March 27, 2019
GO2-19-053

Subject: **COLUMBIA GENERATING STATION, DOCKET NO. 50-397
LICENSE AMENDMENT REQUEST TO REMOVE OPERATING
LICENSE CONDITION 2.C.(11) AND ATTACHMENT 3**

1.0 SUMMARY DESCRIPTION

Figure 1
Item 5 – Side view of the access blockout to duplicate centrifuge room

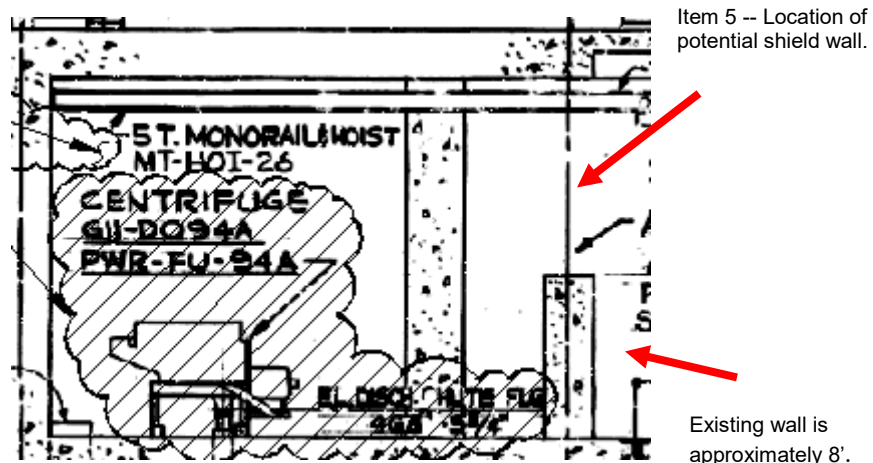
**5. FSAR Figure 12.3-12, Zone G-9 - The access blockout to duplicate centrifuge room.

For Figures 1 and 2, i.e., items 5 and 6, there are existing walls separating centrifuge rooms A and B from the tool decontamination room area. The partial blockout walls were intended to fill the 9'-6" high x 7'-0" wide access openings above the 3' thick 8'-

high concrete walls shown above. These blackout walls above the south concrete walls of centrifuge rooms A and B of the Radwaste Building were intended to provide shielding to the exterior rooms from the shine and scatter generated by the centrifuges. Columbia's FSAR currently makes no mention of centrifuges in either Chapter 11 or Chapter 12. The centrifuges were described in FSAR Amendments 33 through 48 as being used for dewatering ion exchange resins and demineralizer sludges from the various liquid radwaste processing systems in relation to the permanent system.

Items 5 and 6 at centrifuge rooms A and B in the Radwaste Building were meant to support centrifuges which are mechanically and electrically disconnected, deactivated, and spared-in-place. The additional shielding in these areas was to minimize dose to employees outside the rooms from scatter and shine that would have been generated by the centrifuges. The two rooms are now used for storage. Therefore, the radiation levels from these centrifuges will be <2.5 mrem/hr throughout the life of the plant. There is no appreciable dose directly attributable to the centrifuges. Other items stored in the rooms may result in occasional higher dose rates within the centrifuge rooms themselves (see Table 1), in which case existing plant radiation procedures, processes and practices are instituted to maintain regulatory compliance and ALARA.

The license condition language for items 5 and 6 calls out the access cutouts between the centrifuge rooms and the tool decontamination area. The access openings are areas that are 8' off the ground above the existing block wall. This is not generally an area that would be surveyed. Elevated dose rate in that area would only be expected if the centrifuges were functioning.

Figure 2
Item 6 – Side view of the second duplicate centrifuge room

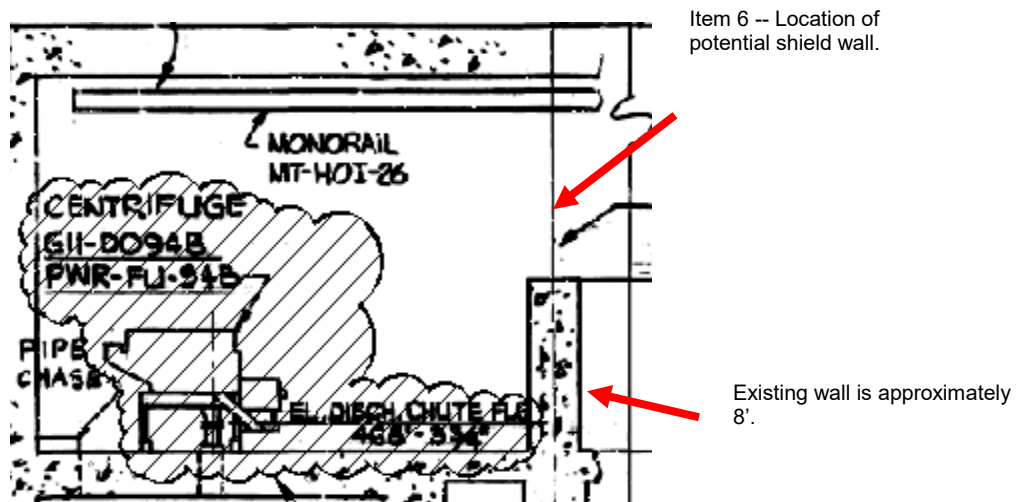
**6. FSAR Figure 12.3-12, Zone F-9 - Same as above for the duplicate centrifuge.

Figure 3

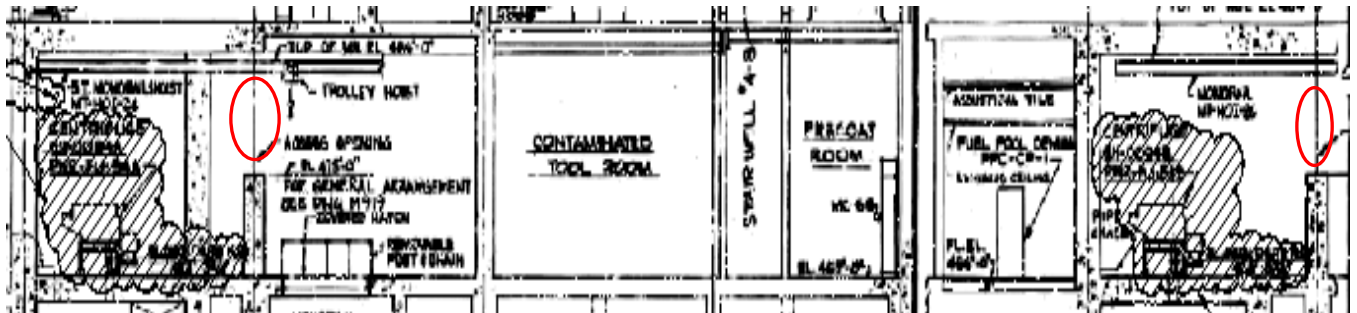
Figure 3 above is an additional side view of items 5 and 6, showing the entire layout of the two duplicate rooms in relation to the tool decontamination room.

Figure 4
Item 7 – top view of the blockout for one of the two decon concentrators

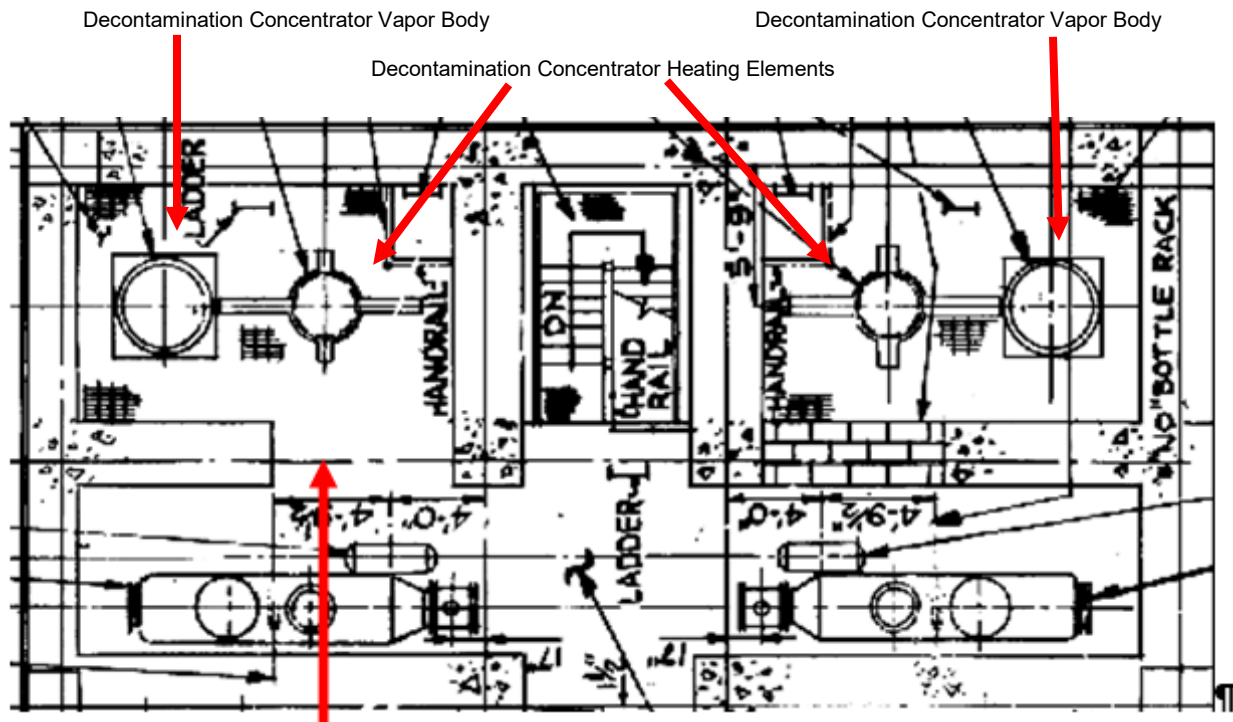
**7. FSAR Figure 12.3-13, Zone J-5 - The blockout for one of the two decon concentrators.

Item 7 -- Location of potential shield wall.

Figure 4 shows that item 7 would have been a removable block wall located in the Radwaste Building and was intended to provide shielding from the decontamination concentrator vapor body and the decontamination concentrator heating element. The FSAR describes the decontamination solution concentrators as currently not used. Portions of the system, which include the decontamination solution concentrators and band associated heating elements, are further identified as equipment deferred for later pre-operational testing and not presently operational. The FSAR describes the decontamination solution evaporator system as deactivated with no plans to use the system.

Item 7 at decontamination concentrator room A in the Radwaste Building was intended to support the decontamination concentrator vapor body and the decontamination concentrator heating element. These items are presently non-operational and there are no plans to use the system. This area is presently not in use. Due to its remote location within the Radwaste Building it has not been used for any routine purpose and is rarely accessed. Therefore, the radiation levels from these components is expected to remain <2.5 mrem/hr.

Figure 5
Items 8 and 9 – (8) top view of the two block walls at the north end of the truck loading bay.
(9) top view of the leaded glass viewing window in the radwaste area.

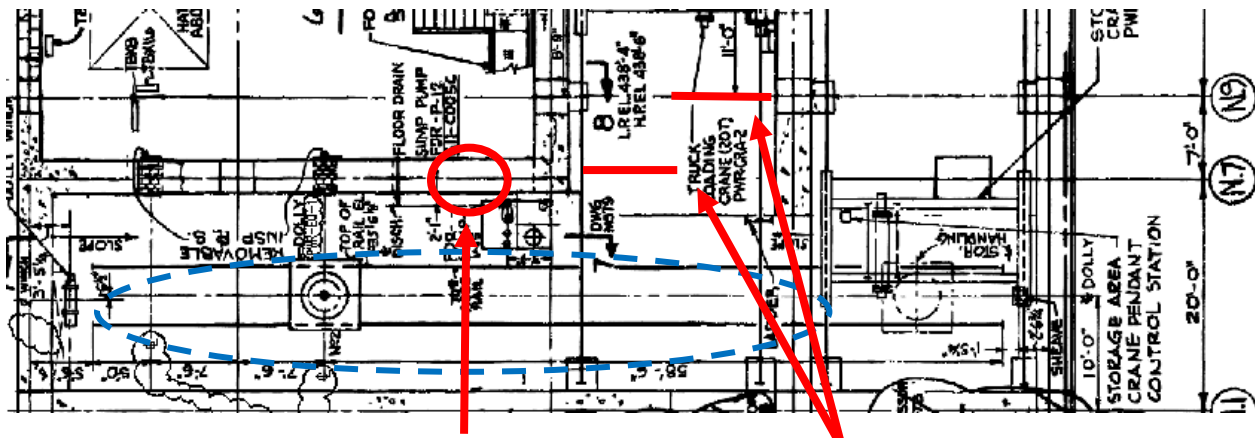
**8. FSAR Figure 12.3-11, Zone D-8 - The two block walls at the north end of the truck loading bay.

**9. FSAR Figure 12.3-11, Zone E-8 - The leaded glass viewing window in the radwaste area.

Item 9 -- Location of potential leaded glass viewing window.

Item 8 -- location of 2 potential block walls. Lines are representative of the wall location not wall thickness.

Figure 5, item 8 is located in the truck loading bay of the Radwaste Building. It is made up of two partial height offset block walls at the north end of the truck loading bay. The walls were intended to provide shielding from disposal containers (i.e., radwaste liners) of dewatered and solidified resin slurries and filter sludges while these containers were on the transfer dolly at the storage area station.

Figure 5, item 9, the leaded glass viewing window near the decon station control panel was intended to provide shielding while also providing the ability to monitor filling, capping, decontamination, surveying and handling of radwaste disposal containers on the transfer dolly at the container filling station. The area where the leaded glass viewing window would have been situated is now a solid concrete wall.

To support the permanent system's original design, the area with the dashed circle on Figure 5, would have had solid waste slurries processed through one of the centrifuges (Figures 1 and 2), through a mixing hopper and discharged to a 50 cubic foot disposal container on the transfer dolly at one of two container filling stations. Individuals would ostensibly have monitored this process from the viewing window. The containers would have been within line of sight from the open area of the truck bay. (Figure 5, item 8). As previously discussed the permanent system is not in operation. If the permanent system was in use the entire area where items 8 and 9 are located would be areas of significant dose. The container filling station area is currently used for material storage and the location of the leaded glass viewing window is a concrete wall.

Item 8, which is at the north end of the truck loading bay in the Radwaste Building, currently has dose rates that at times exceed 2.5 mrem/hr. This dose comes from filled radwaste disposal containers on the transfer dolly. This occurs only when these containers are being transferred from the liner storage area (i.e., the "NUPAC Cage") to a truck trailer for shipment to the off-site disposal facility. The current ALARA practice is to limit personnel access to the radwaste processing area during container transfers. ALARA practice, requires the crane operator to position themselves behind the shielded frisking booth during container transfer operations. Thus, dose rates to personnel are generally maintained <2.5 mrem/hr. Currently, the two off-set shield walls, if installed, would be more of an impediment to the safe and efficient handling and transfer of radwaste containers than any dose-reduction benefit that might be gained. The ALARA assessment is that the shielded frisking booth at the north end of the truck loading bay provides sufficient shielding for crane operators during waste transfer operations.
